Enclosed herewith is "Notice of Revision and Addendum in Contract Documents," Addendum 11, consisting of two (2) pages and other attachments as referenced in the addendum. This addendum is dated April 14, 2026, and pertains to Contract 21-092-3P, "Battery E Activated Sludge Facility, O'Brien Water Reclamation Plant."

**ADDENDUM 11**

**CONTRACT 21-092-3P  
BATTERY E ACTIVATED SLUDGE FACILITY  
O'BRIEN WATER RECLAMATION PLANT**

Sheet Number:  
**C-016**  
 Page Number: 32

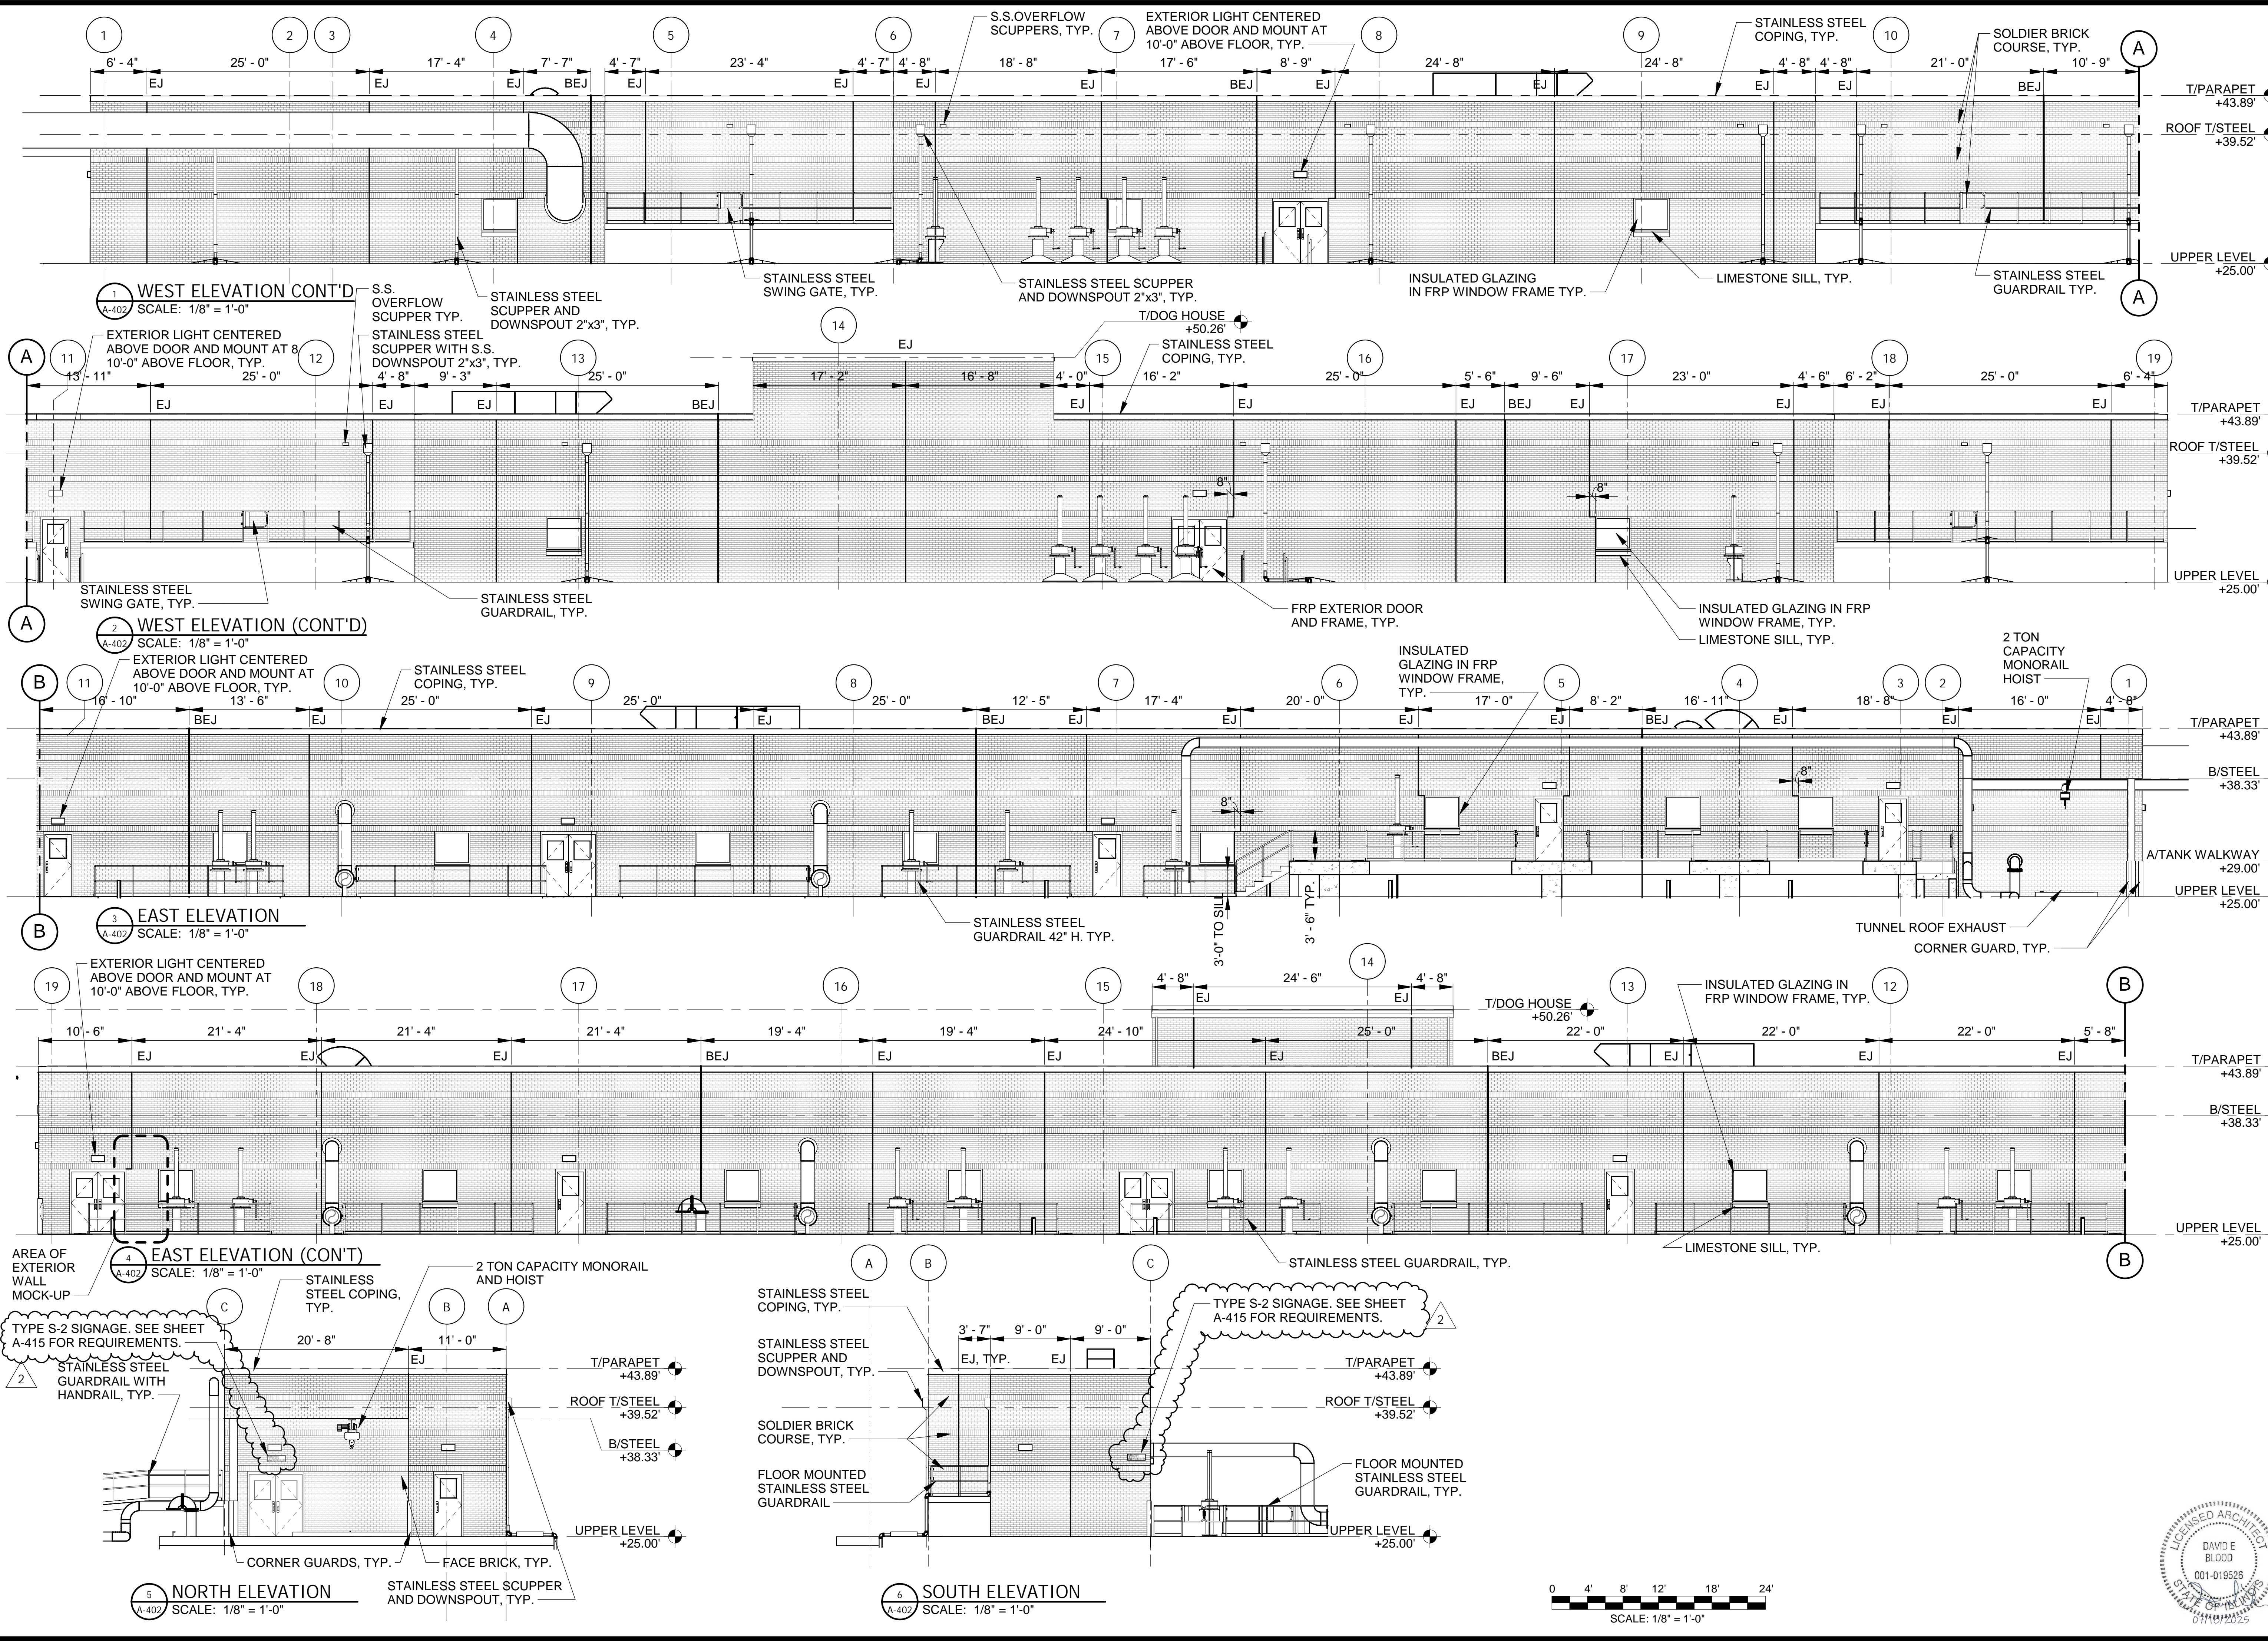
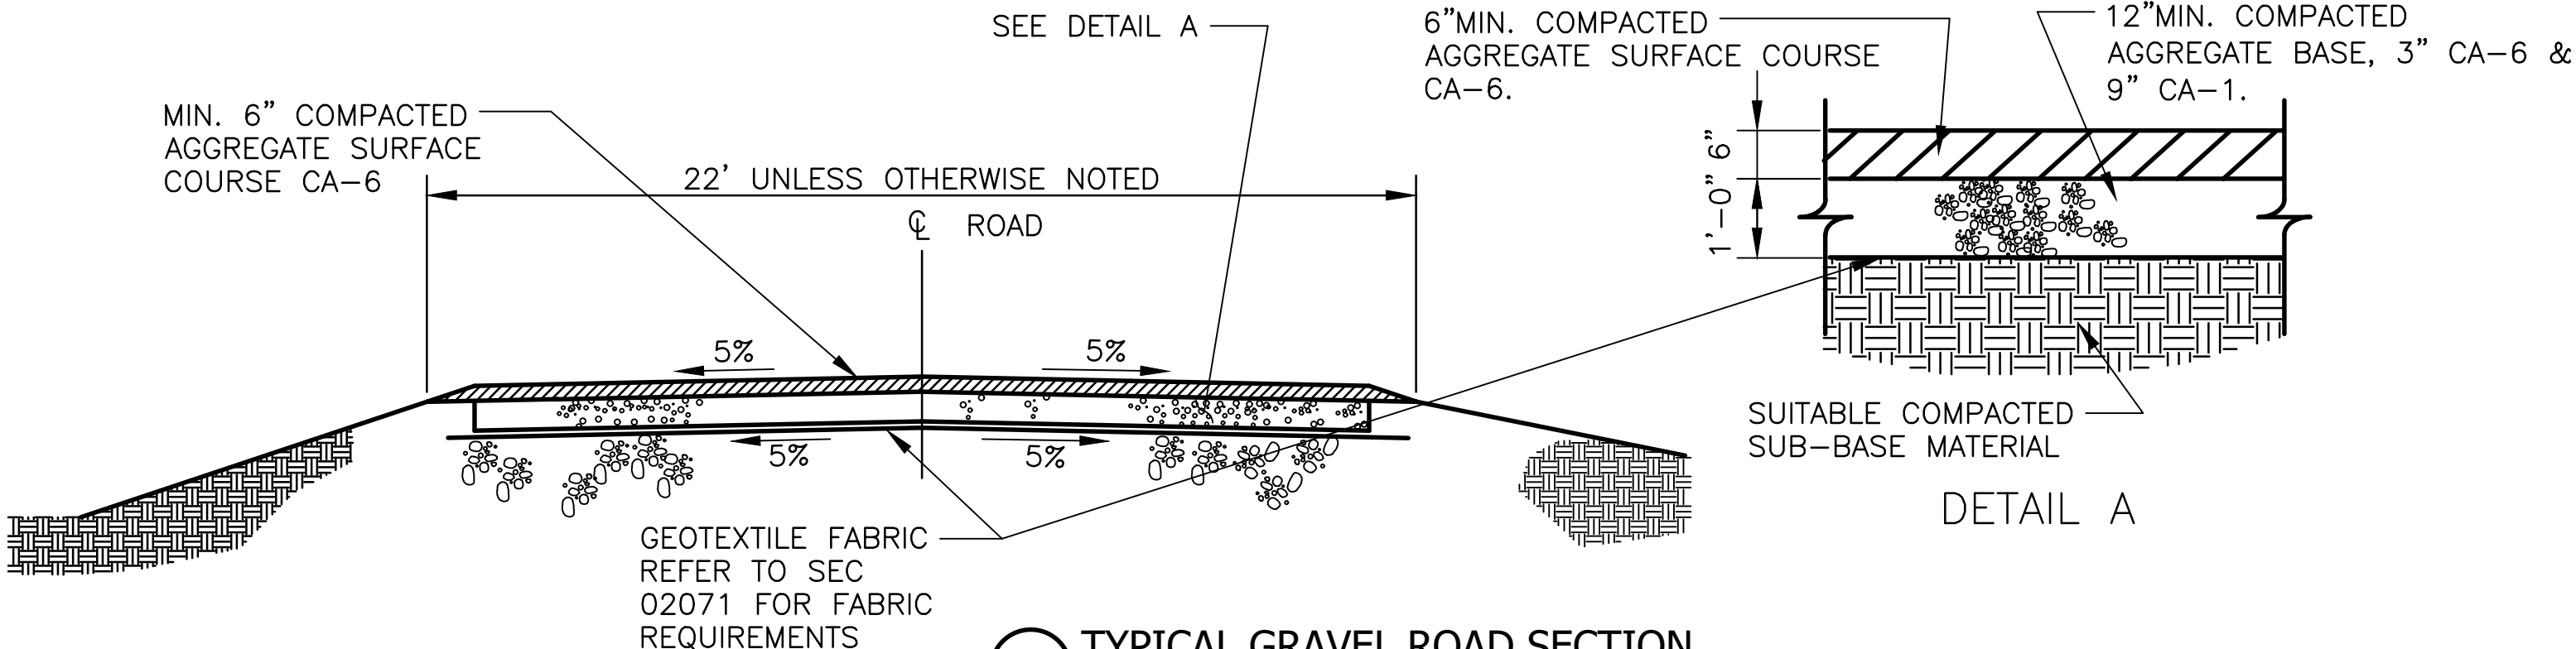
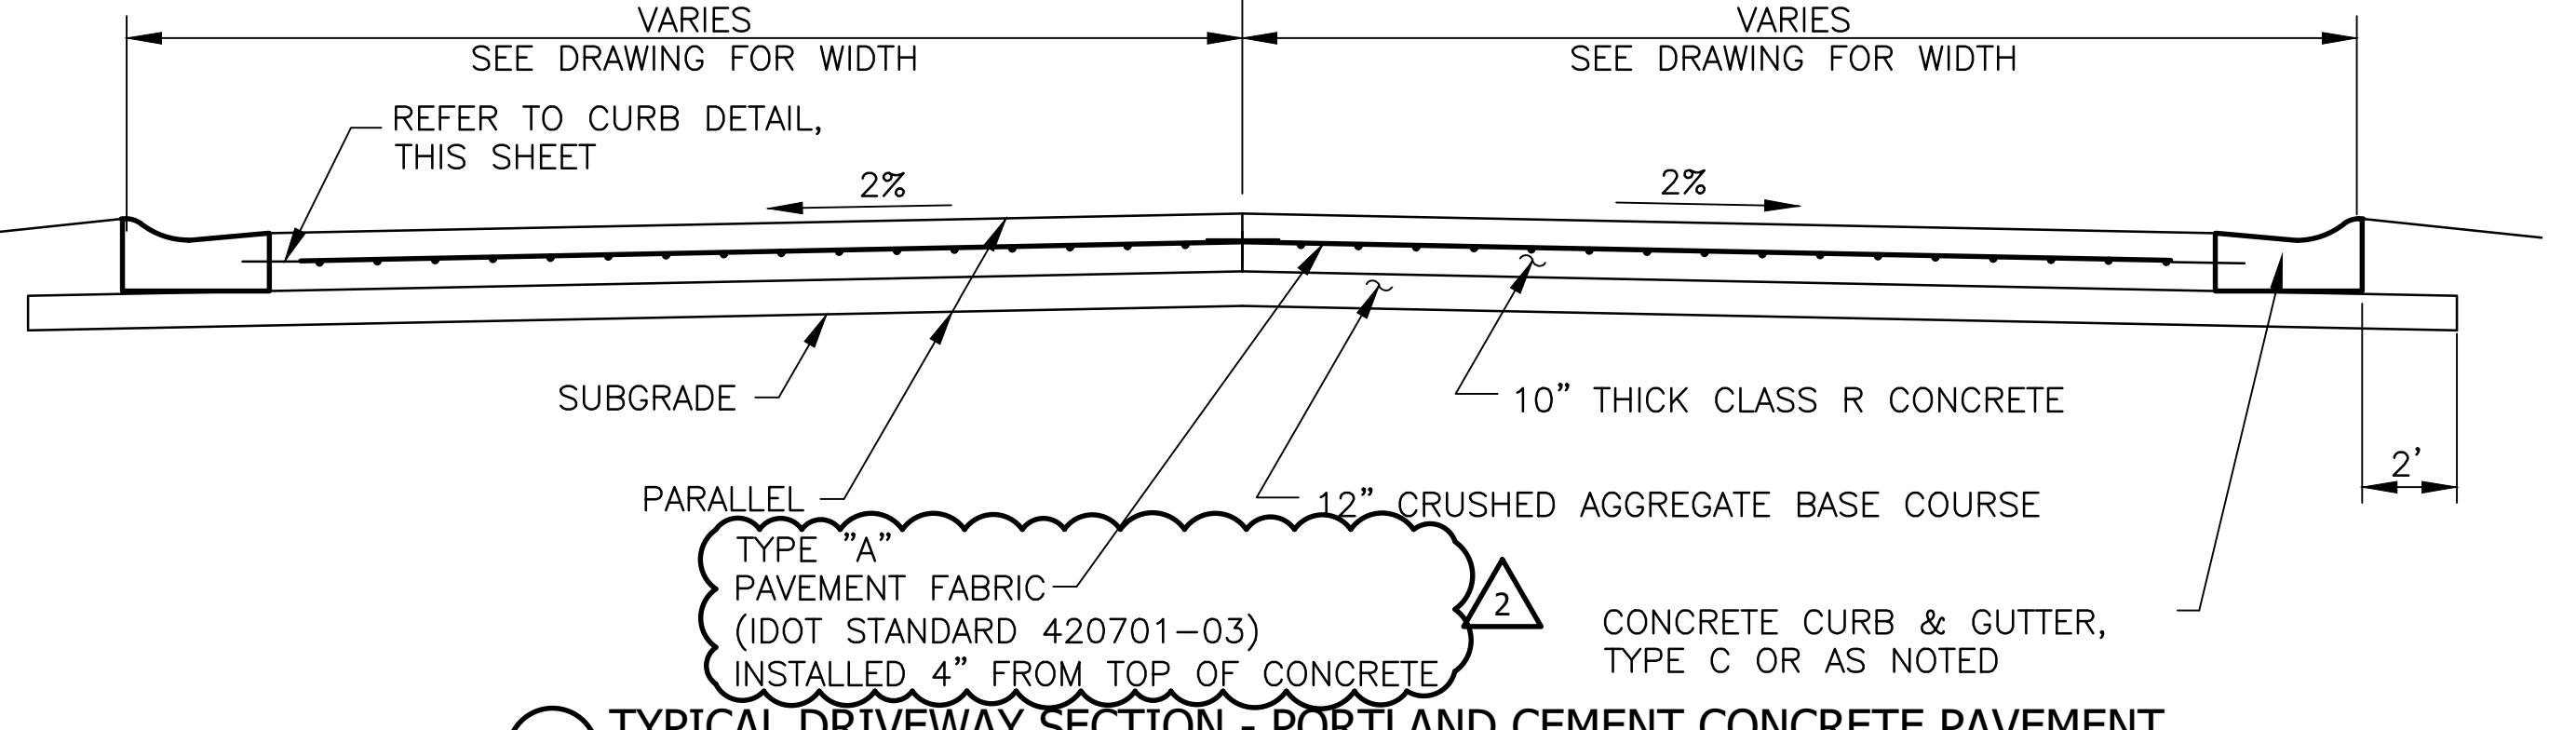
| <u>PAGE NO.</u> | <u>SHEET NO.</u> | <u>REV#</u> | <u>TITLE OF SHEET</u>                      |
|-----------------|------------------|-------------|--|
| 32              | C-016            | 2           | STANDARD DETAILS - 5                       |

| Rev. | Description     | Appr. | Date    |
|------|-----------------|-------|---------|
| 2    | ADDENDUM NO. 11 | HC    | 4/13/26 |
